March 24, 2017

L-MT-17-010  
10 CFR 50.90

Monticello Nuclear Generating Plant License Amendment Request: Revision to Emergency Plan Staff Augmentation Response Times

**LICENSE AMENDMENT REQUEST:  
REVISION TO EMERGENCY PLAN STAFF AUGMENTATION RESPONSE TIMES**

**Figure 13.1**  
**MONTICELLO PLANT EMERGENCY ORGANIZATION**

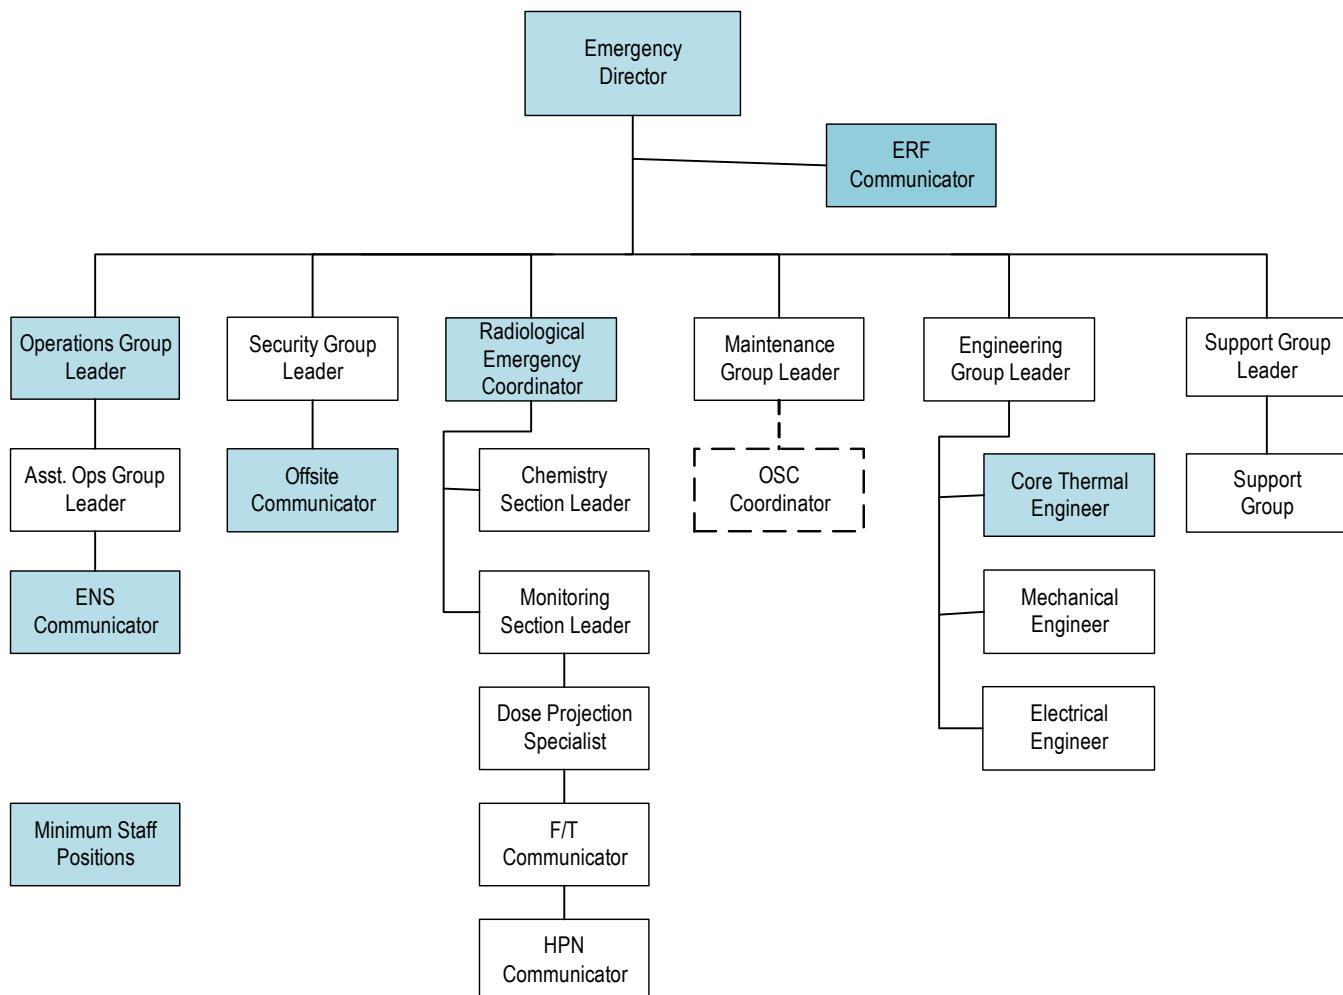
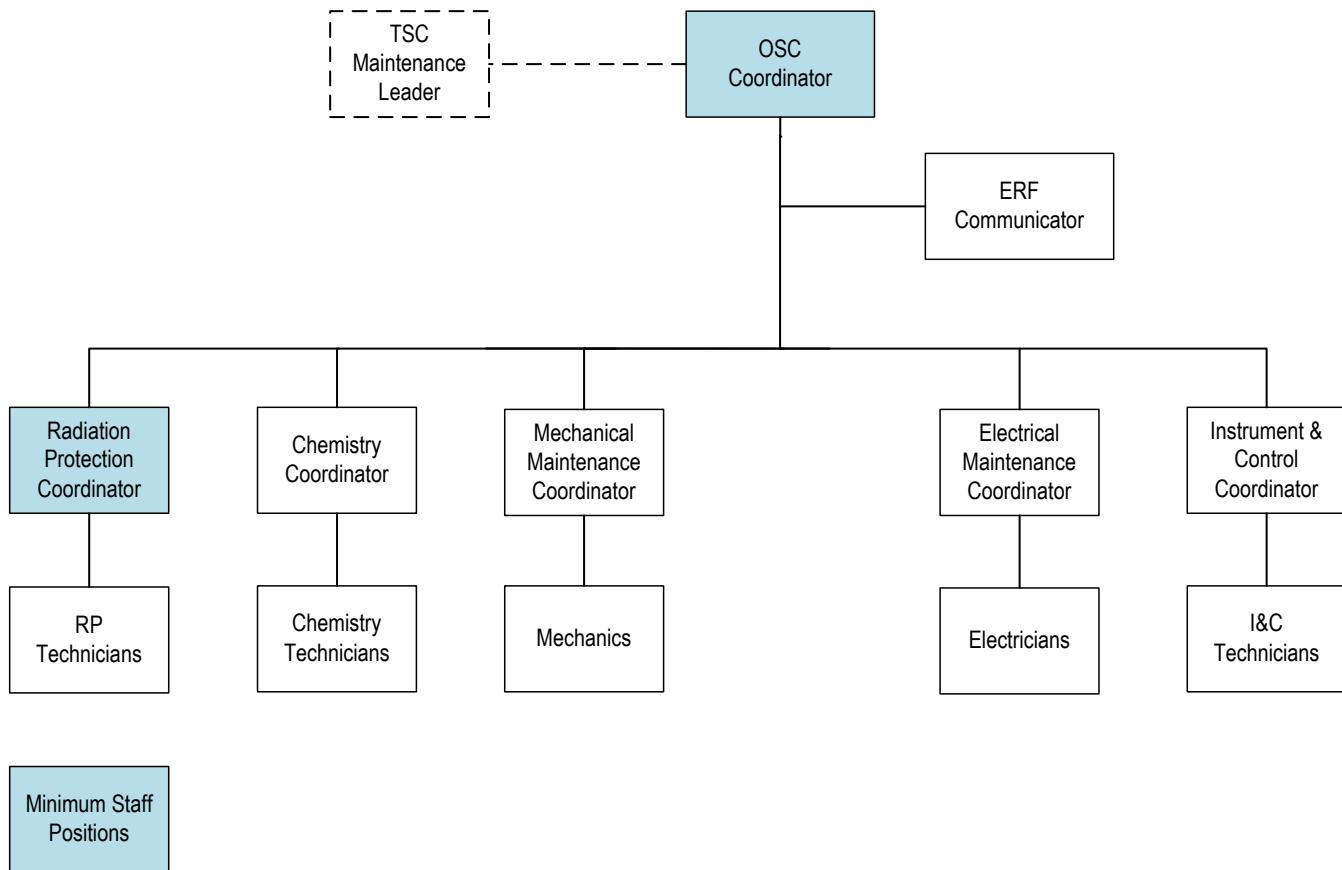
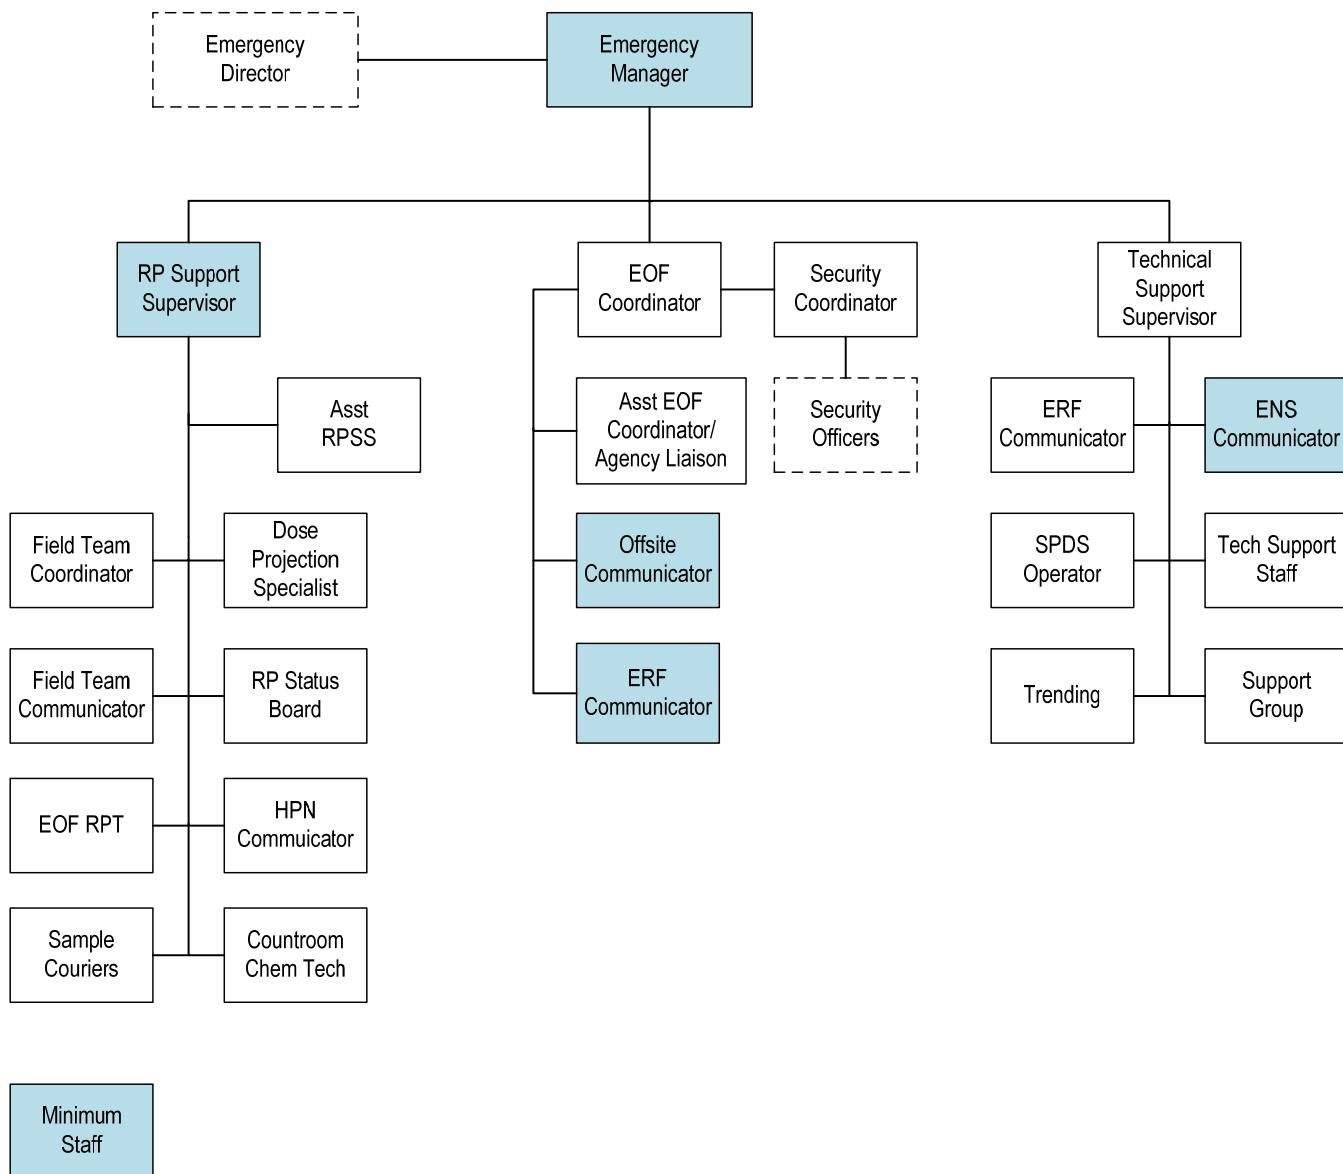
- r. Section 9.5, “Long Term Recovery,” changed ‘activated’ to ‘entry into’ to maintain alignment for use of ‘activated’ throughout the document.
  - s. Section 13.0, “Figures,” specifically Figure 13.1 was changed to separate TSC, OSC and EOF organizational structures and identify minimum staffing positions required for facility activation.

**Technical Support Center**  
Positions Report Within 60 Minutes

Positions Report Within 60 Minutes Unless Otherwise Indicated on Table 1

Emergency Operations Facility  
Positions Report Within 90 Minutes
